17/18-MB1: Organic Farm Parking Lot Improvement, Indian Valley Campus

ADDENDUM #2

Bid Addendum No. 2

Date of Issuance: 02 August 2017
Project Name: College of Marin Indian Valley Campus
Organic Farm Parking Lot Improvements
Project Number: 1102-0005
Client: College of Marin

GRADING AND DRAINAGE PLAN

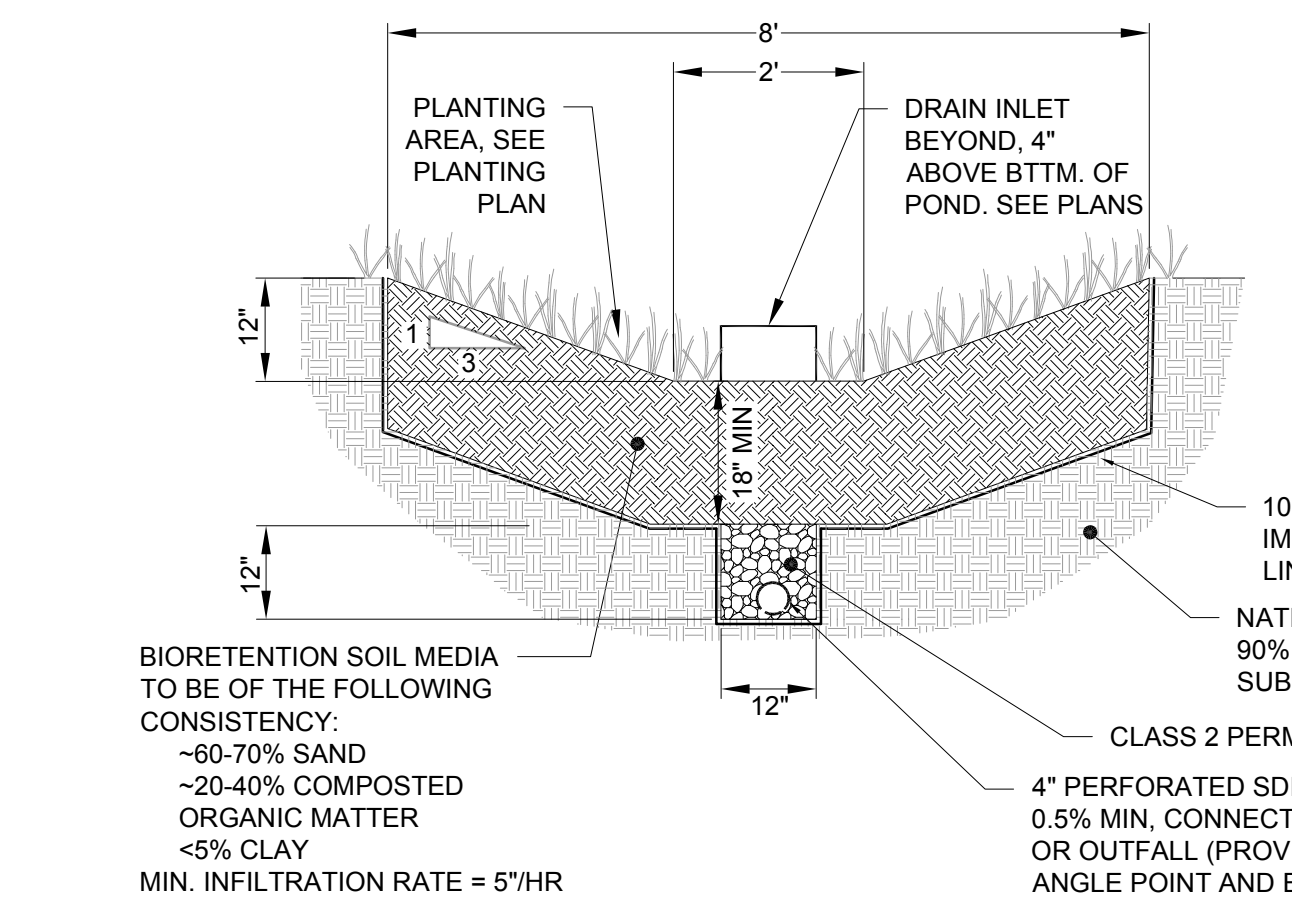
- C1.00 Demo Plan (New sheet)
- C2.0 Grading and Drainage Plan (Replacement Sheet)
 - Parking lot and stair layout revisions
- C3.0 Utility Plan (Replacement sheet)
 - Parking lot and stair layout revisions
- C4.0 Civil Details (Replacement Sheet)
 - Detail revisions
- C5.0 Erosion Control Plan (New Sheet)

SITE PLAN

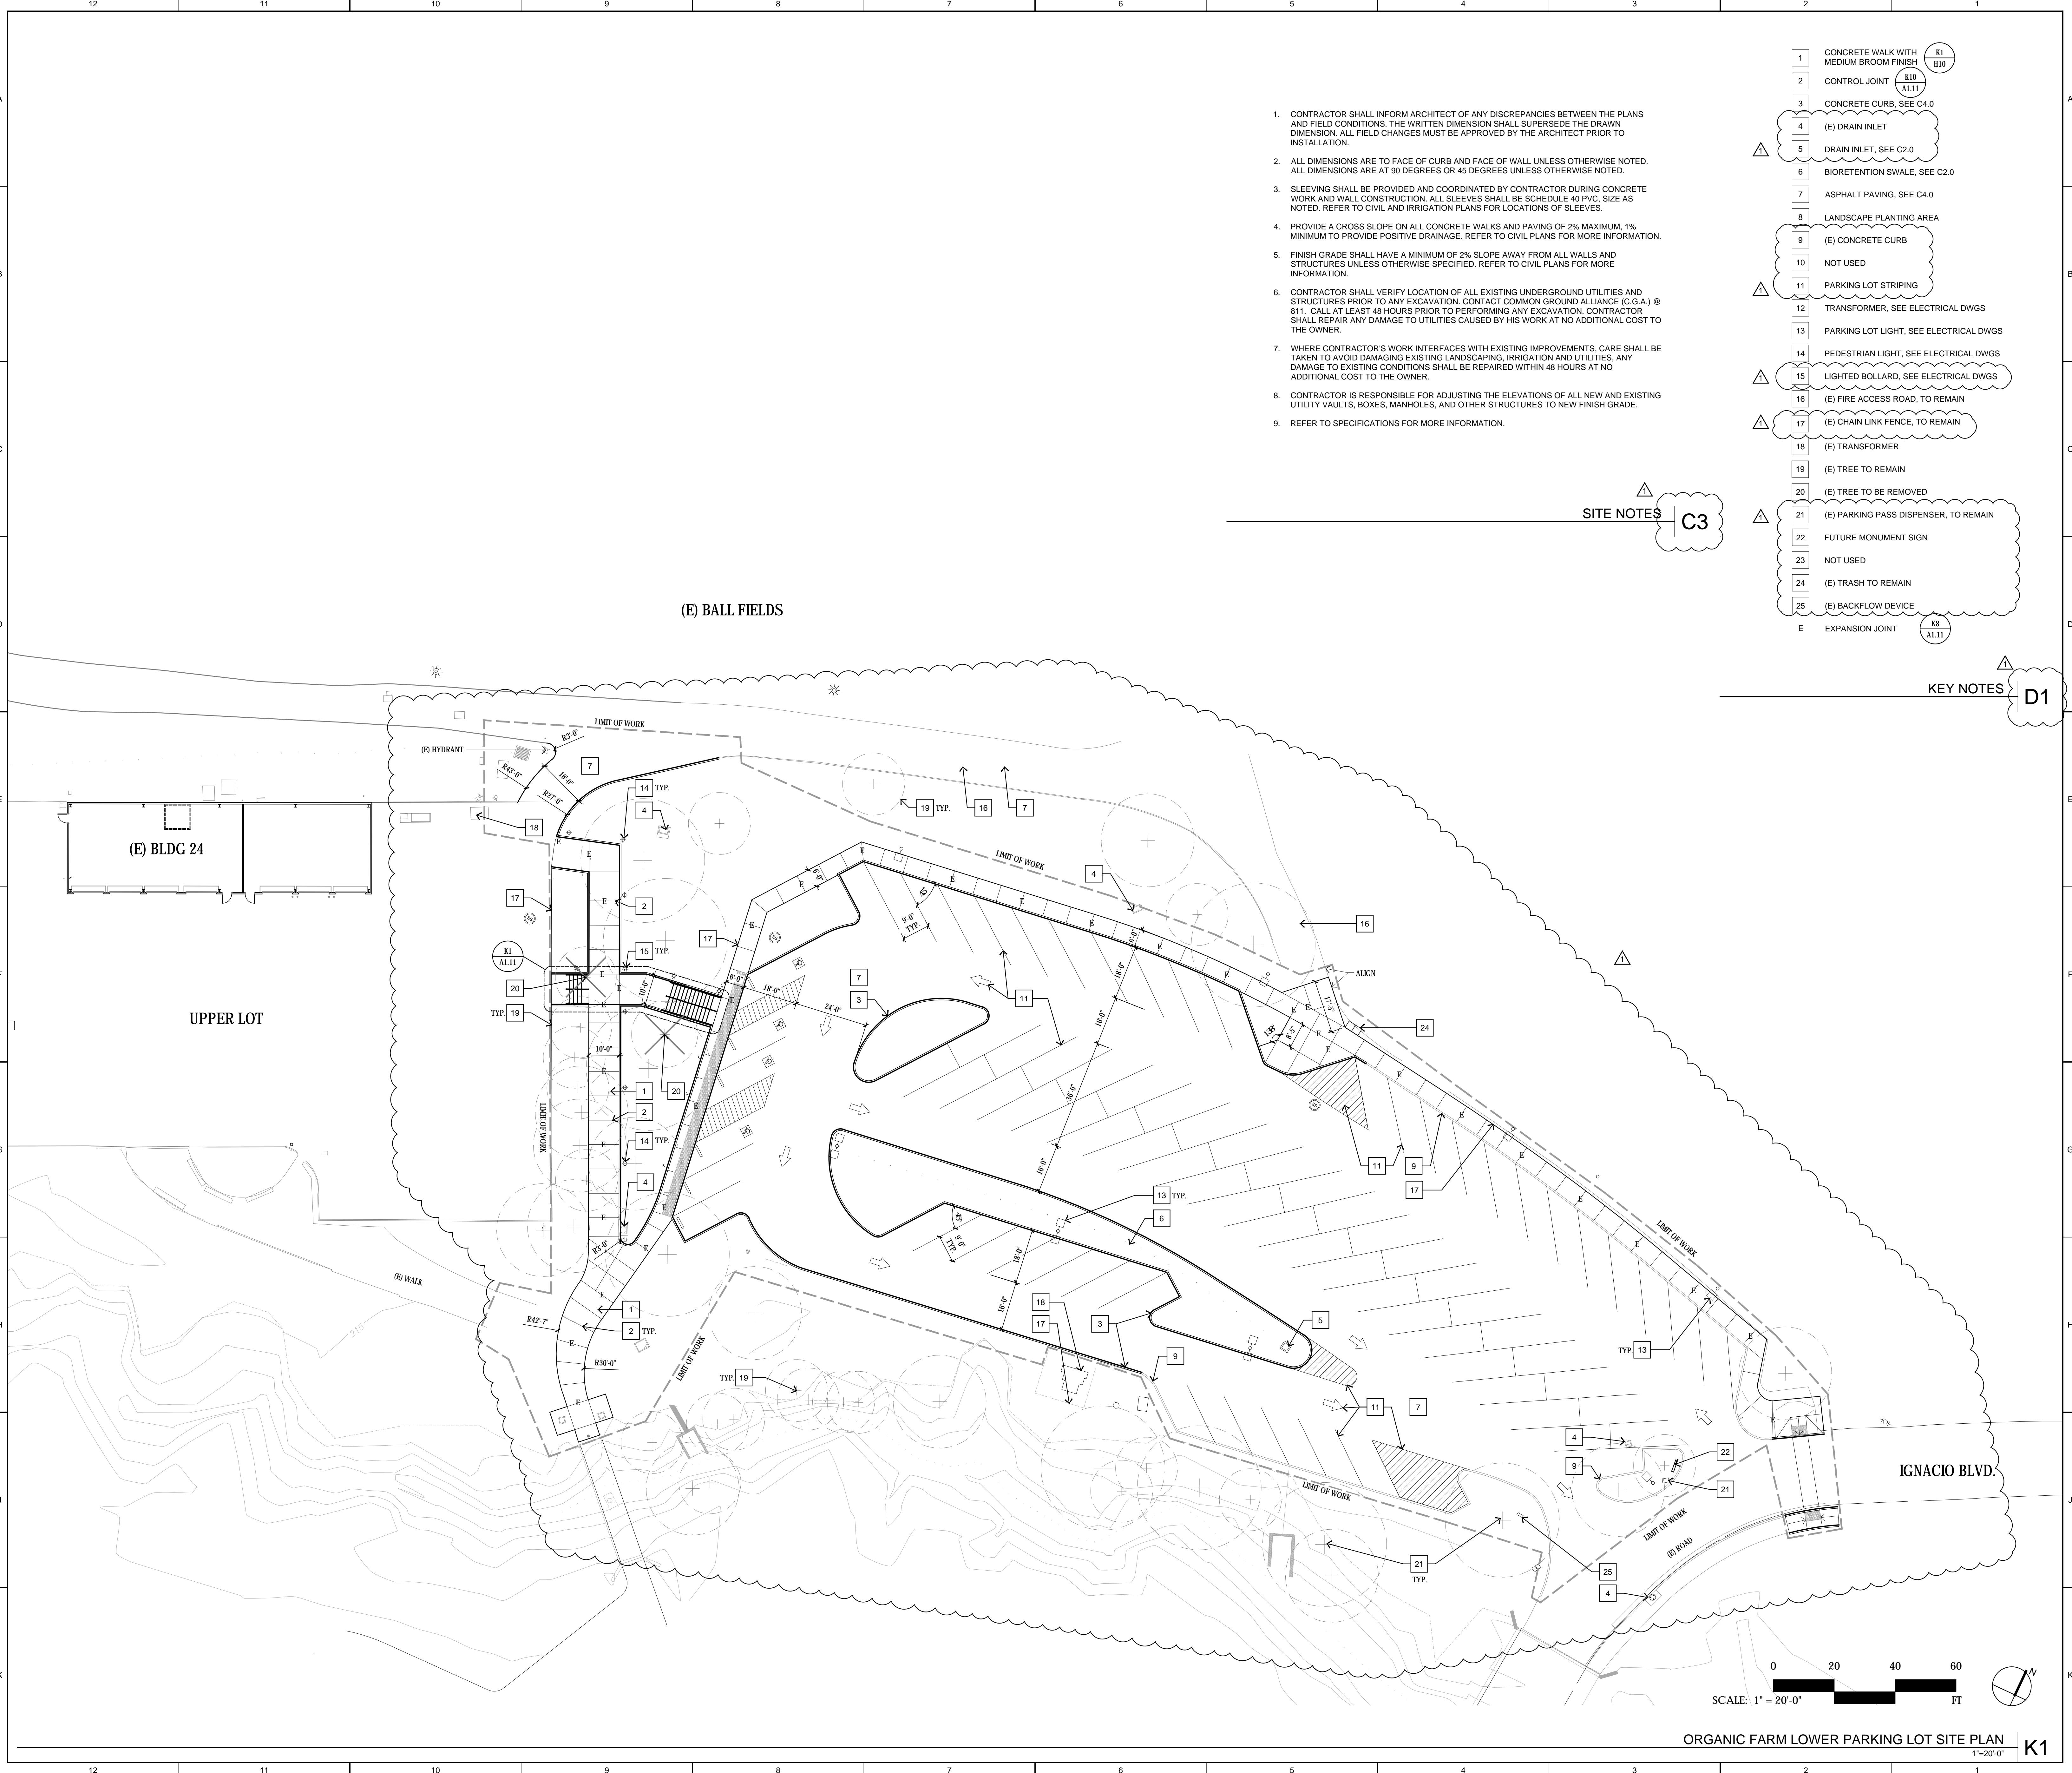
- A1.00 Site Plan (Replacement sheet)
 - Parking lot and stair layout revisions
- A1.11 Site Details (Replacement Sheet)
 - Stair layout revision

SYMBOLS LIST, DRAWING INDEX & DETAILS

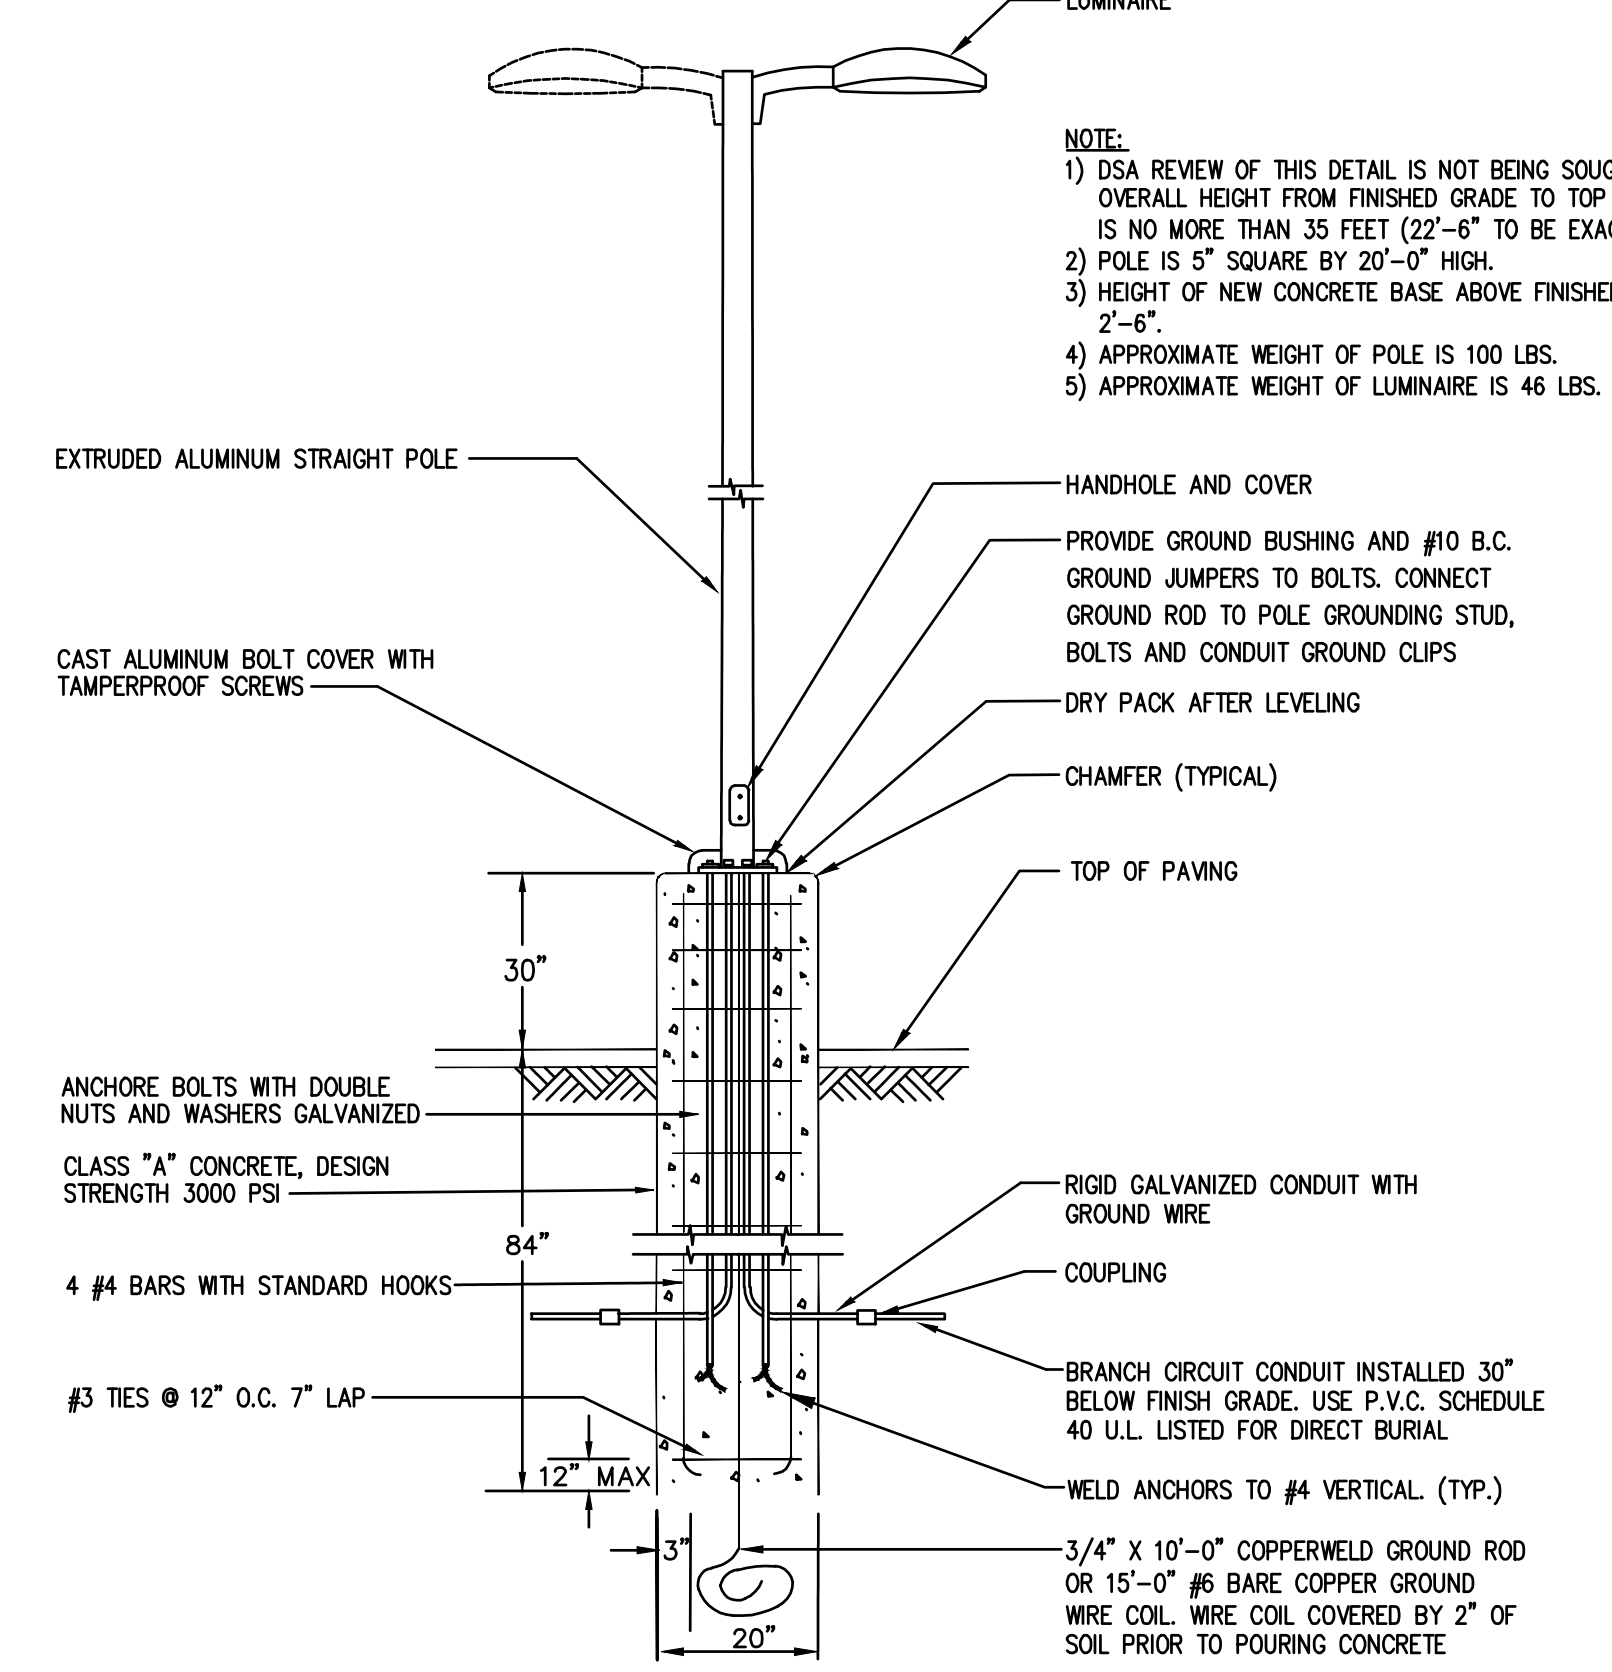
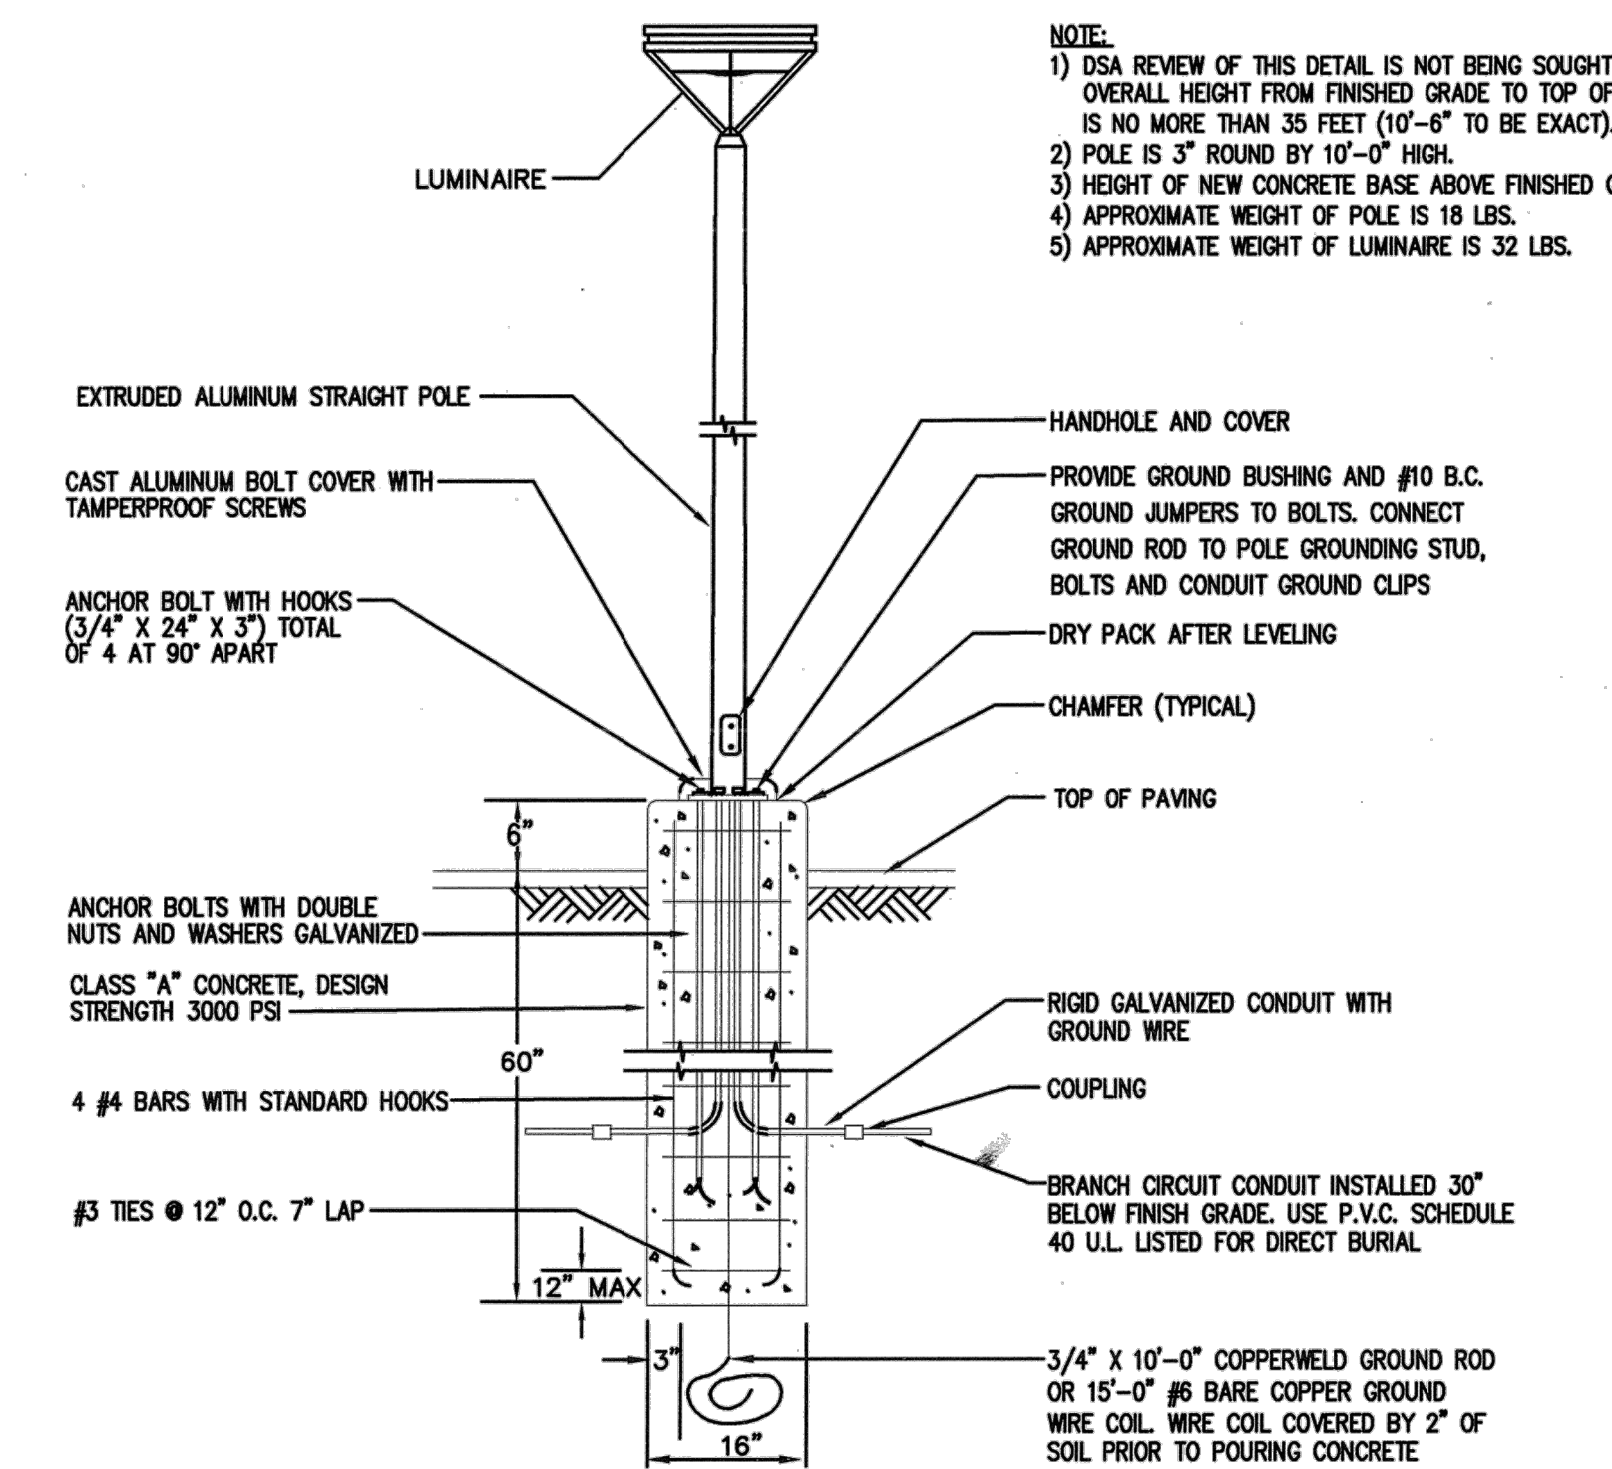
- E0.01 Symbol List, Drawing Index & Details (Replacement sheet.)
 - Revision to fixture schedule
- E1.00 Electrical Site Plan (Replacement sheet)
 - Revision to lighting
 - Conduit requirements added
